Groundwater Application Review Summary Form

Application # G- 19263

GW Reviewer Joe Kemper Date Review Completed: 11/30/2023

A. GENERAL INFORMATION: Applicant's Name: City of Prineville County: Crook

Well Location Maps

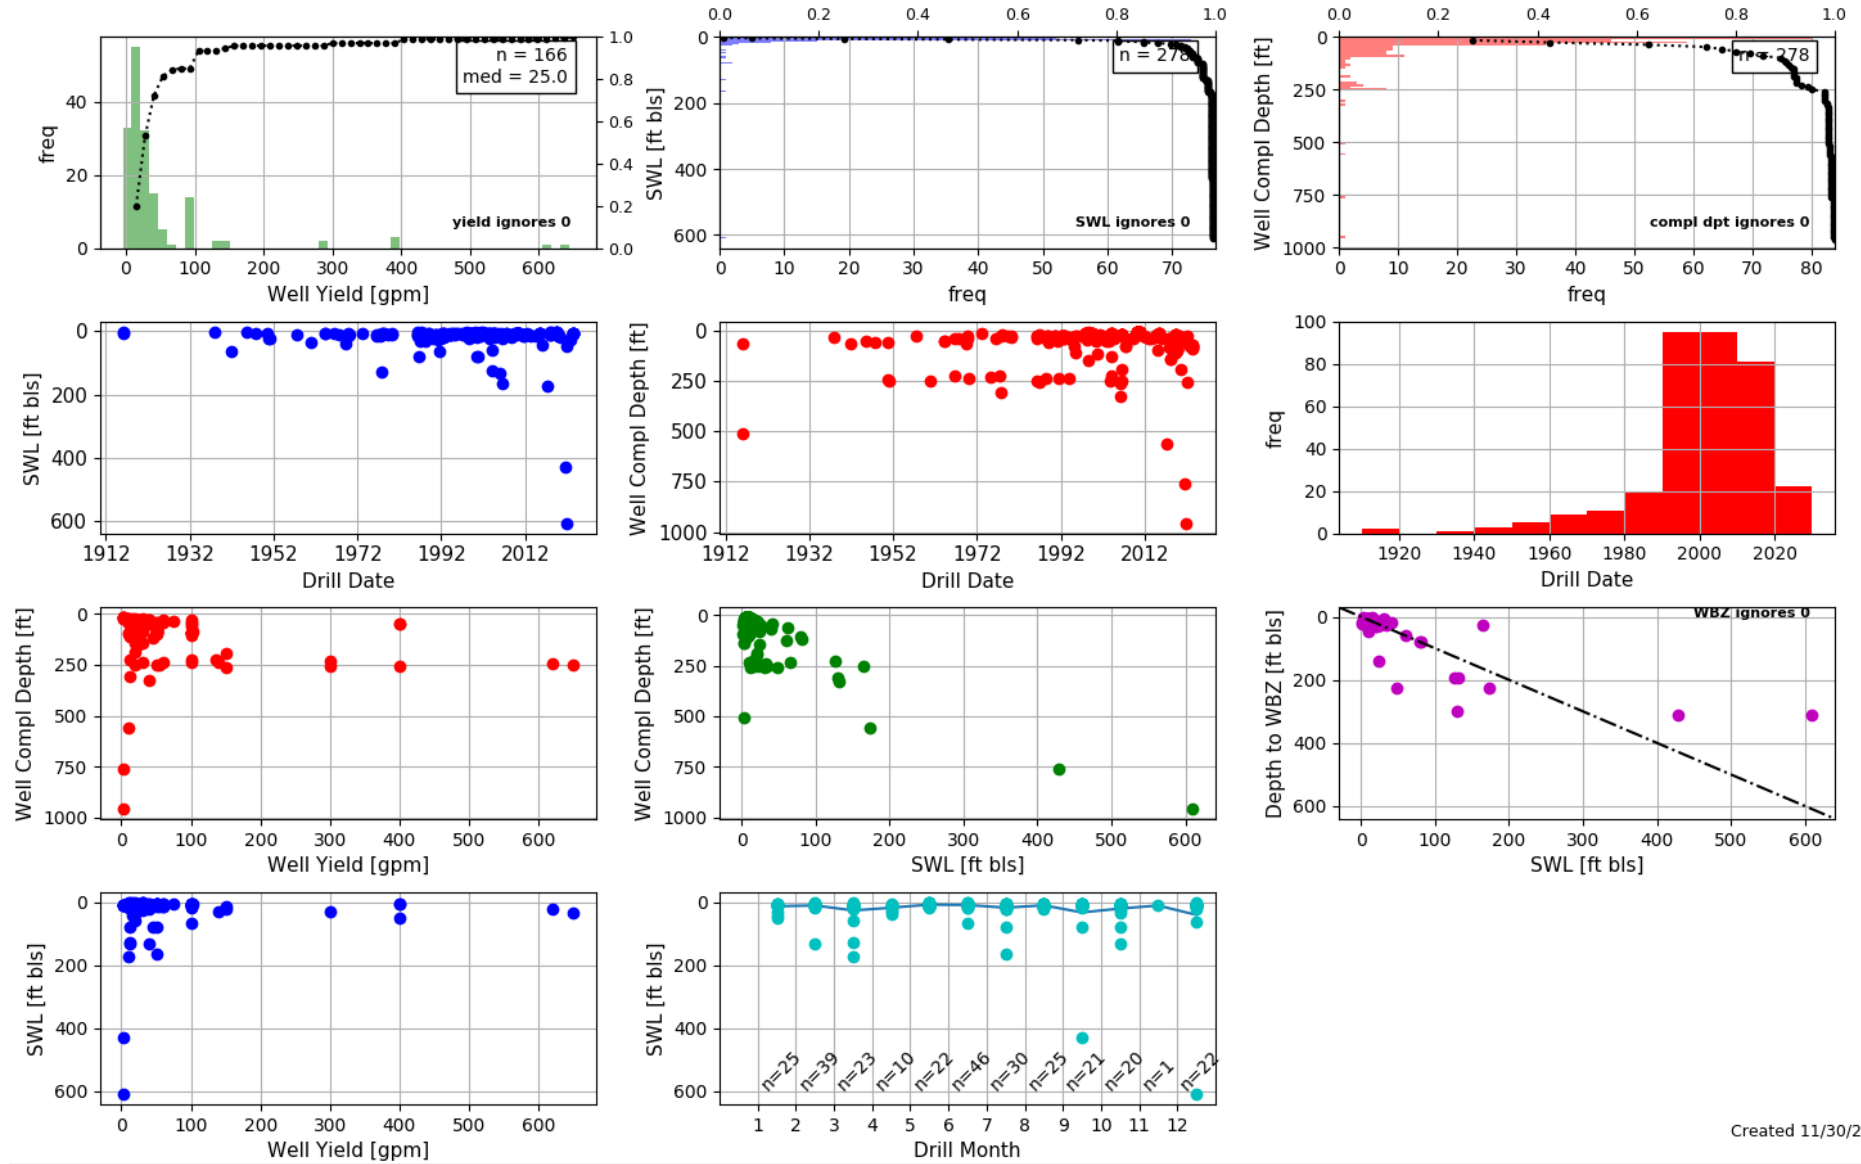
B3. **Groundwater availability remarks:** There are three distinct sediment facies underlying the Crooked River within the Prineville valley: 1) 25-100 feet of late Quaternary, fine-to-coarse grained alluvium ranging in depths of ~25-100 feet, 2) mid-late Quaternary fine-grained lacustrine deposits likely resulting from one or more lava dams downstream, and 3) mid-late Quaternary-aged 10–30-foot thick package of coarse-grained alluvium underlying the lacustrine deposits at depths of 200-250 feet. The applicant’s wells access groundwater hosted in the shallow younger alluvium immediately adjacent to the Crooked River. SWLs from wells in shallow alluvium are typically between 1-10 feet BLS and cluster near the elevation of the adjacent Crooked River (~2860 feet amsl). There is little seasonal and interannual variation in observed SWLs (see CROO 2130). Water levels in the deeper, confined alluvium show greater seasonal and interannual fluctuations (see CROO 2133 and CROO 50181). Available water level data in the shallower alluvial aquifer do not indicate consistent, year-on-year declines. It likely has an efficient hydraulic connection to the Crooked River, which acts as a consistent recharge source. Use from the applicant’s wells is expected to come almost fully from capture. Those impacts are addressed by the Deschutes Mitigation program. Well-to-well interference with other senior groundwater users is not likely to cause injury considering the distance to adjacent wells and the Crooked River serving as a recharge source.

Summary statistics for TRS 15S/16E sections 5 and 8 show that, of all wells shallower than 200 feet, only one had an estimated yield higher than 100 gpm; rather, median yield for these shallower wells is 25 gpm. The requested rate of 4.46 cfs for wells H1, H2, and H3 would normally be found not within the capacity of the resource because it is far above what aquifer can supply to normal water supply wells. However, the higher permitted rate may be possible because of the proposed horizontal, collector style construction.
